PNG CPCN WESTERN TRANSMISSION REACTIVATION AND DEFERRAL ACCOUNT INCREASE EXHIBIT A-6

Re: Pacific Northern Gas Ltd. – Certificate of Public Convenience and Necessity for the Western Transmission Gas System Reactivation and Recommissioning Project Application and Deferral Account Increase Application – Project No. 1599200 – Information Request No. 1

INFORMATION REQUEST NO. 1 TO PACIFIC NORTHERN GAS LTD.

Figure 5-9: Project Roadmap

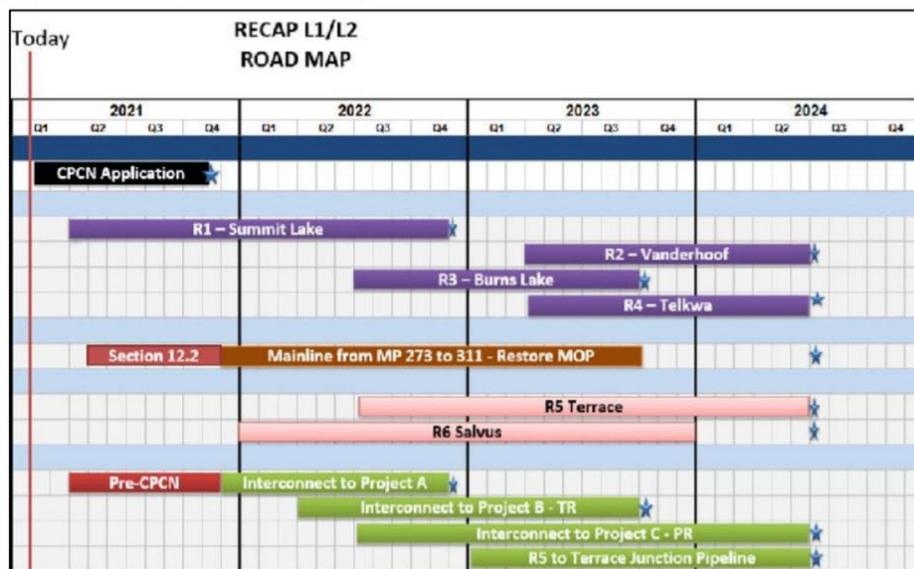
25.1 Please discuss whether PNG has assessed the optimal scheduling of each Project component in order to mitigate against the risk of any RECAP customer demand not materializing (i.e. to ensure all reactivated capacity is ultimately required). If so, please explain how this assessment has been incorporated into the Project schedule.

25.2 Please provide the expected operating pressure profile of PNG’s Western Transmission System
